**Joint Comments by the American Petroleum Institute and the
Association of Fuel & Petrochemical Manufacturers on**

The U.S. Environmental Protection Agency Proposed Rule

***Control of Air Pollution from Motor Vehicles: Tier 3 Motor Vehicle
Emission and Fuel Standards***

Docket ID No. EPA-HQ-OAR-2011-0135

Figure 1: PM data from Table 1.8 of the EPA proposed Tier 3 rule

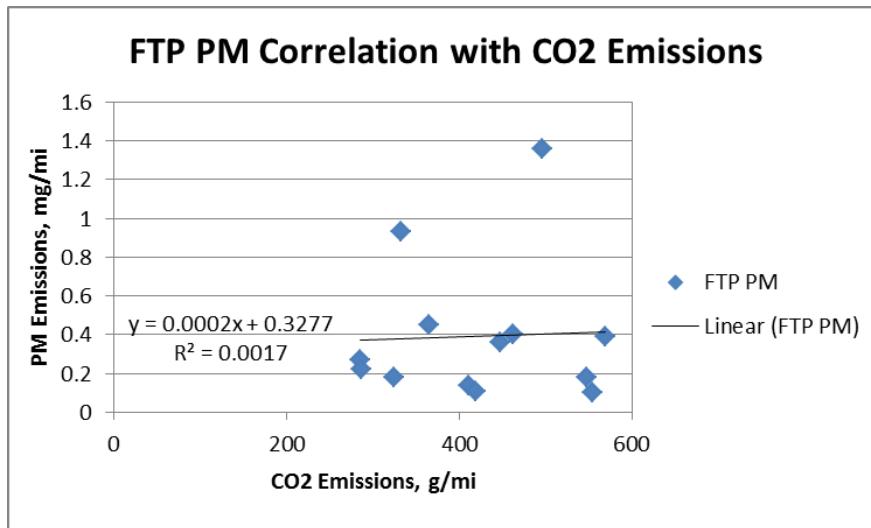
While not part of the comments on sulfur effects, we are concerned about statements made on PM emissions in the PM feasibility section of the DRIA. EPA indicates that “FTP PM emissions increased with CO₂ emissions for the PFI vehicles” and “As in the case of FTP results, US06 PM emissions increased with the increase in CO₂ emissions in PFI vehicles”. Our review of the data in Tables 1-8 and 1-9 show very little correlation of CO₂ emissions and PM emissions for either drive cycle but as EPA does not indicate how they determined a correlation we would need to conduct some additional review of the docket material “Test Program to Establish LDV Full Useful Life PM Performance” to fully understand their comment. Below we show a plot of the PM data from the FTP testing as listed in Table 1-8.

Figure 4: ENVIRON modeling: change in ozone levels from Tier 1 to Tier 2

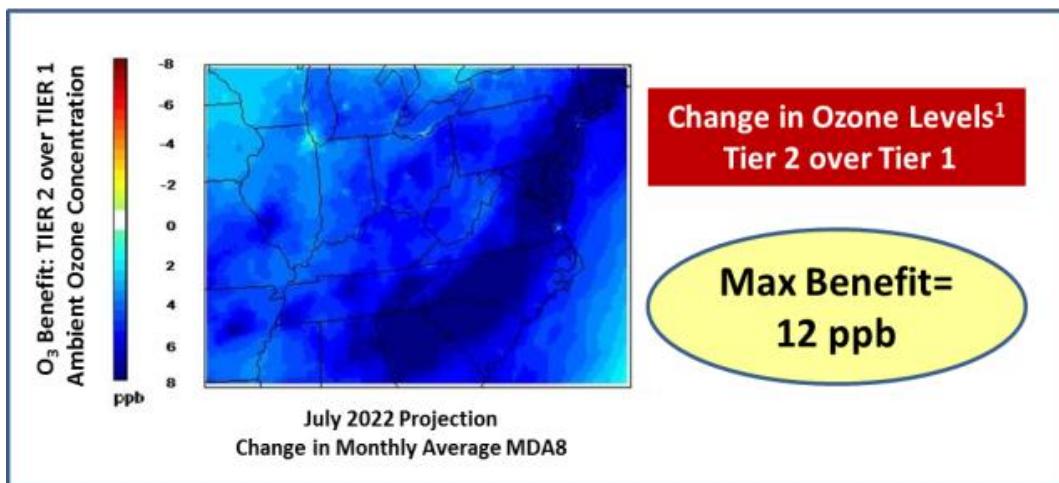
occurred (and are expected to continue) as a result of Tier 2. As shown in Figures 4 and 5 below, the maximum ozone benefit expected from Tier 3 is less than 1 ppb, relative to a maximum ozone benefit of 12 ppb anticipated from the federal Tier 2 program.

Figure 6: ENVIRON modeling: change in PM_{2.5} levels from Tier 1 to Tier 2

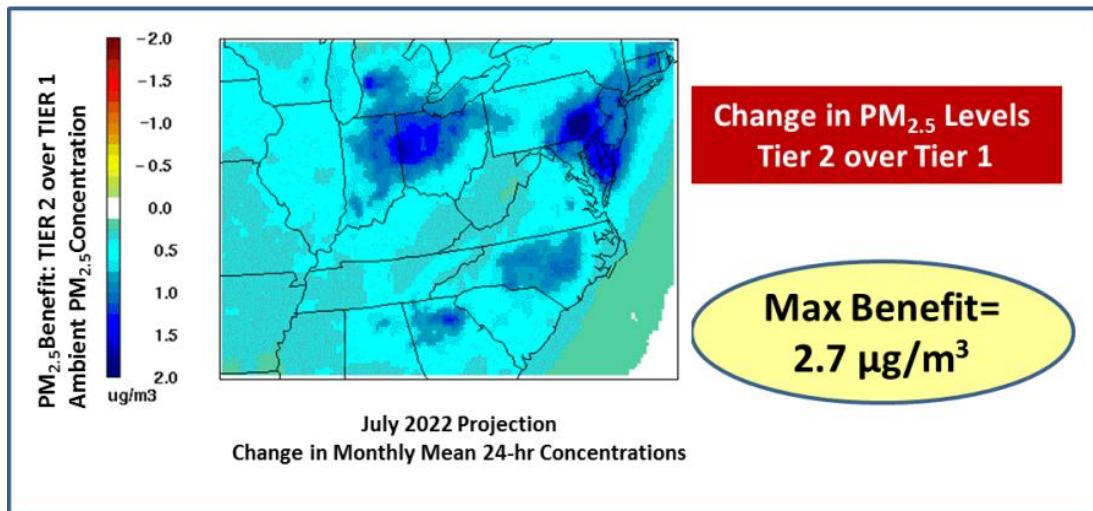
Similarly, ENVIRON concluded that incremental reductions in the monthly mean of ambient PM_{2.5} concentrations attributable to Tier 3 will be negligible in comparison to those expected from Tier 2. The study showed that Tier 3 would yield incremental reductions in mean monthly summer 2022 PM_{2.5} concentrations of no more than 0.1 µg/m³ in contrast to a maximum incremental reduction of 2.7 µg/m³ in mean monthly PM_{2.5} ambient levels under the federal Tier 2 program. See Figures 6 and 7 below.

Figure 8: Market Octane Cost (premium spread divided by octane number difference) and Gasoline Prices. Source: Platts, Annual averages of daily prices.

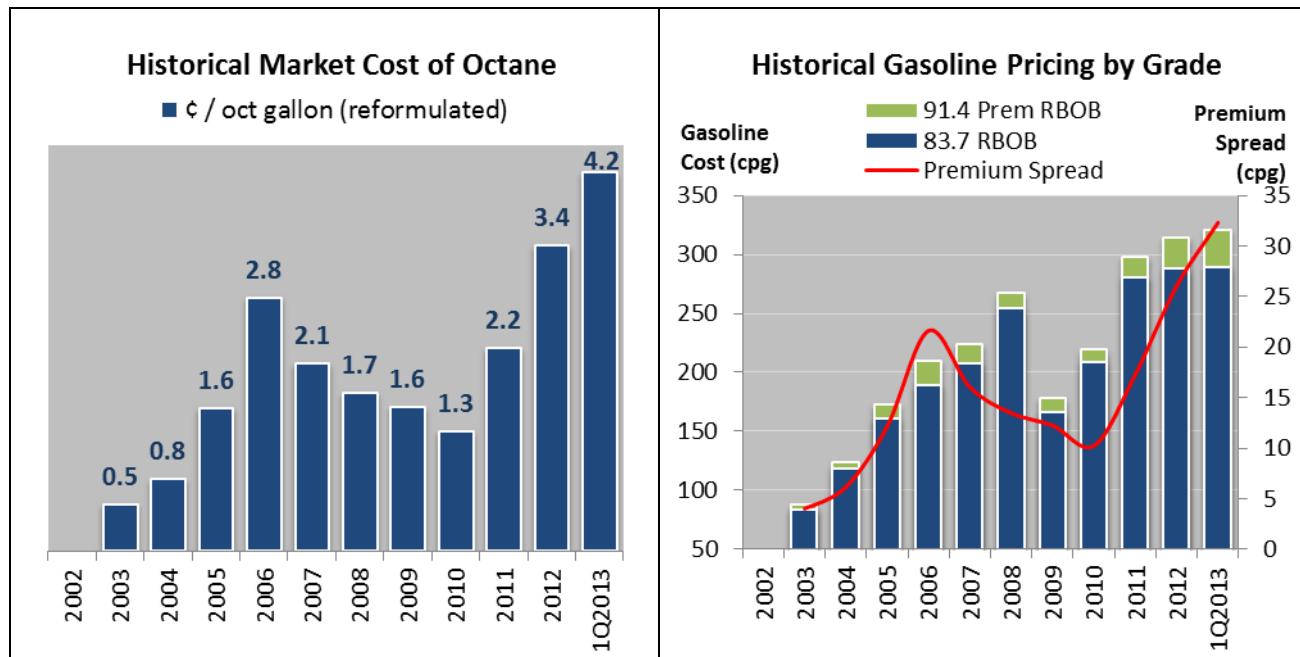
Finally, this low octane cost per gallon of gasoline does not align with the trend of market octane cost. By examining the spread between premium and regular grades of gasoline, and knowing the difference in octane value of each grade, a cost/octane gallon can be calculated.

Figure 8 above shows the annual average of daily posted prices and makes it clear that octane is getting more expensive, even as ethanol blending has saturated the market. Unless the market is assumed to be inefficient, it would appear octane has value and it is increasing. This is in direct contradiction to EPA's assessment that costs associated with octane destruction through desulfurization are largely negligible as described in the prior paragraph.

Figure 12: Percentage of Total PM-related Mortalities Avoided by Baseline Air Quality Level

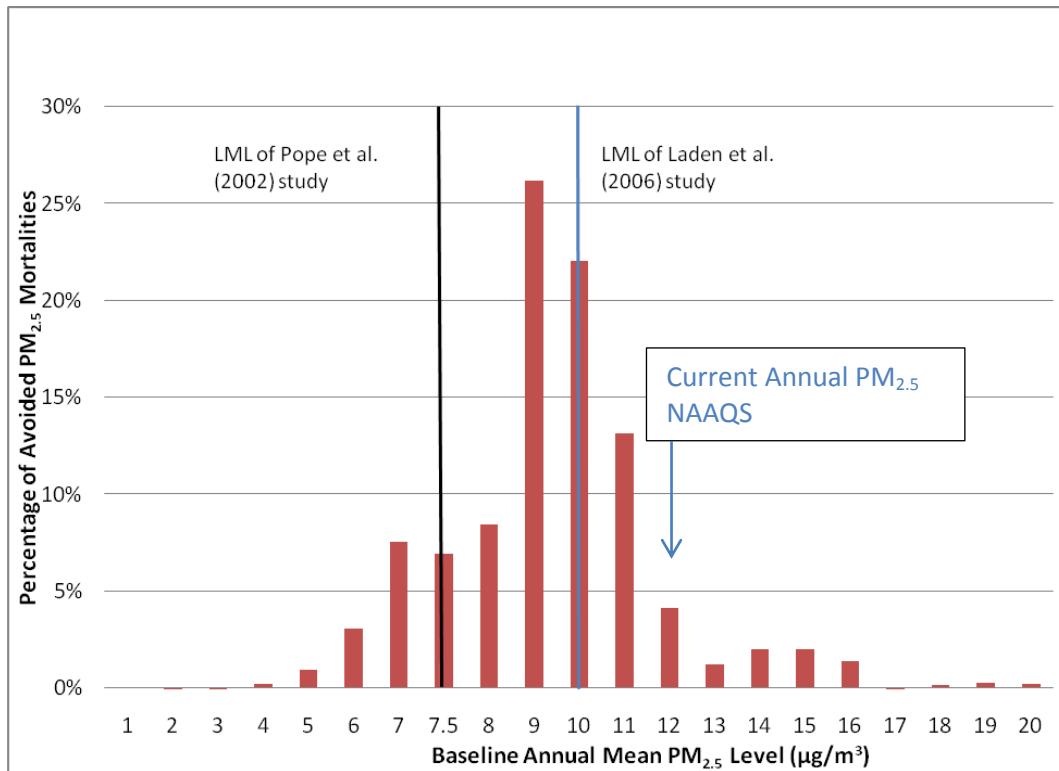
Over 90% of the benefits result from reducing ambient levels of PM_{2.5} well below the NAAQS level (see Figure 12 below). Since a large fraction of the U.S. population lives in areas where the

$\text{PM}_{2.5}$ levels are well below EPA's recently revised NAAQS, EPA assumes that ambient exposures even near background present an equal risk. EPA should not calculate mortality or other health benefits below the NAAQS for PM and ozone, levels.

If EPA set aside the economic benefits of the Tier 3 rule that are estimated below the NAAQS for PM and ozone, and ignored all of the other changes suggested here, the benefits of this rule would be markedly reduced (90% reduction) and would fall in the range of \$0.8-2.3 billion. In this case, EPA's estimated costs of the rule (\$3.4 billion) would exceed the benefits by about 1.5-4 fold.

Figure 13: Reversibility of Gasoline Sulfur Effects on Exhaust Emissions from Late Model Vehicles

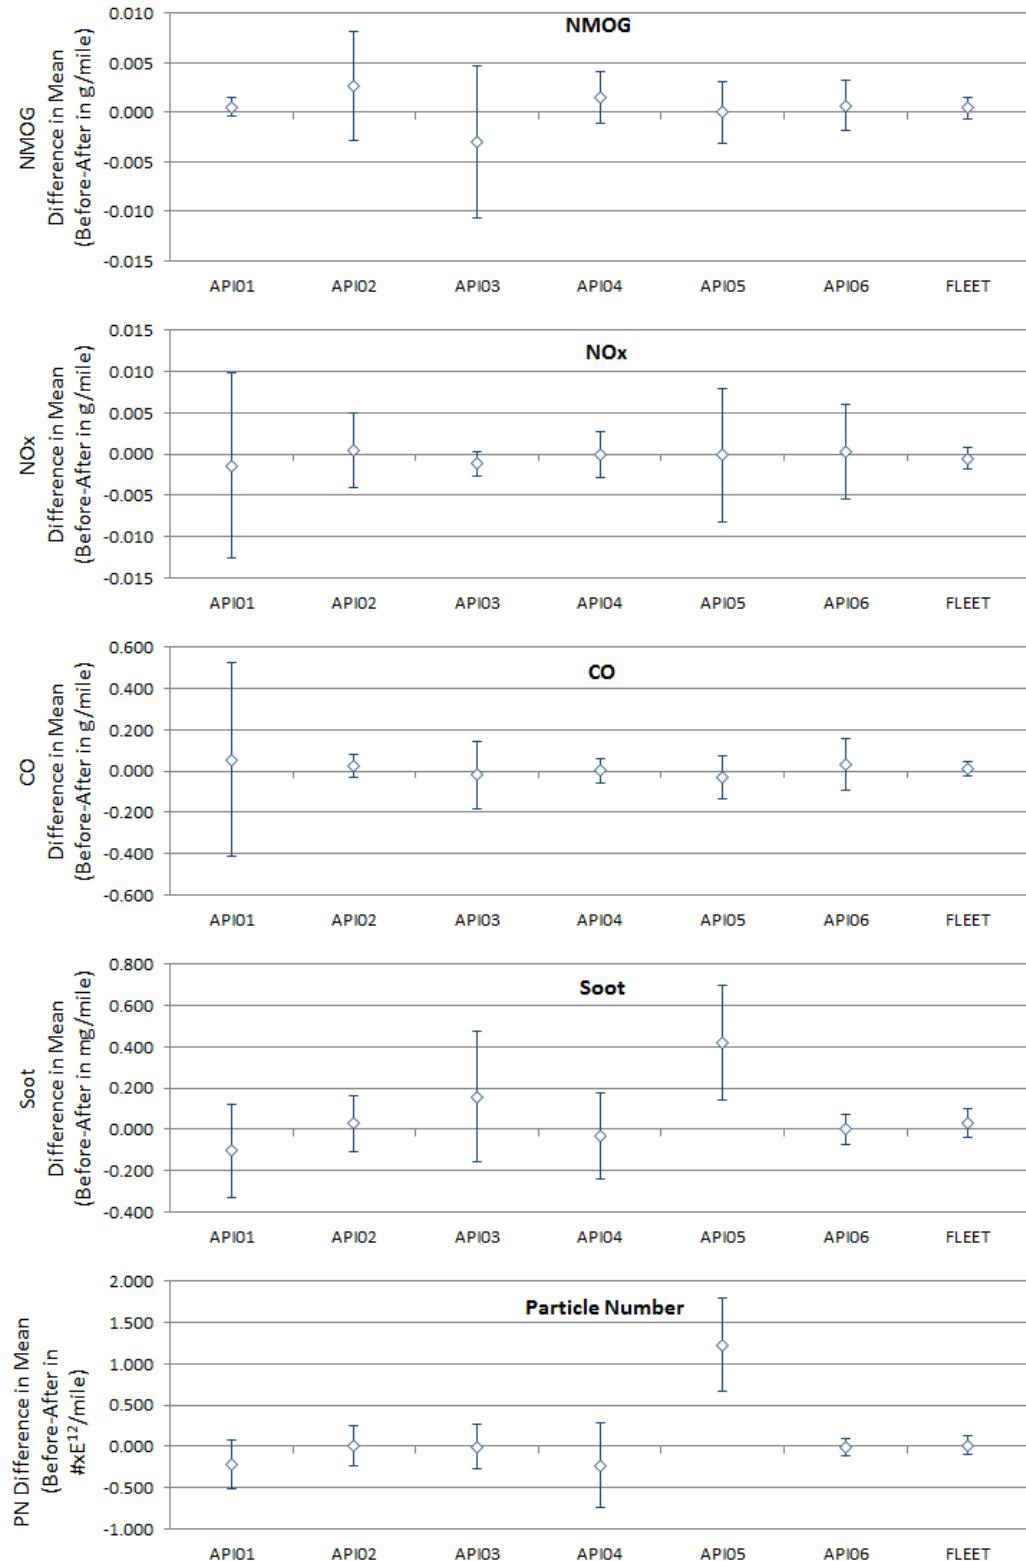
Figure 13 (below) evaluates the reversibility of the sulfur effects by comparing emissions before and after the exposure to 80 ppm fuel. The mean emissions after the exposure to the high sulfur fuel are subtracted from the mean emissions for the initial baseline on 10 ppm sulfur fuel, 95% confidence intervals are calculated for the difference, and the results are plotted for each of the six individual test vehicles and for the fleet as a whole. If the confidence interval for the emissions difference does not include zero, then emissions on 10 ppm sulfur fuel after exposure to 80 ppm fuel are statistically different from the initial 10 ppm baseline. If the entire confidence interval is less than zero then emissions are statistically higher after exposure to 80 ppm sulfur, indicating that sulfur effects are not fully reversible. If the confidence interval includes zero, then mean emissions before and after exposure to the 80 ppm fuel are not statistically different and the hypothesis that the sulfur effects on emissions were irreversible would be rejected.

Based on the statistical analysis of the results as summarized in Figure 13, the study concluded that, for each vehicle tested and for the test fleet as a whole, the change in NMOG, NO_x, CO, Soot and PM emissions resulting from exposure to 80 ppm S fuel was quickly reversed upon returning to operation on 10 ppm S gasoline. There was greater than 95% confidence that the differences in the mean emissions values measured before and after the high sulfur fuel exposure were not statistically different.
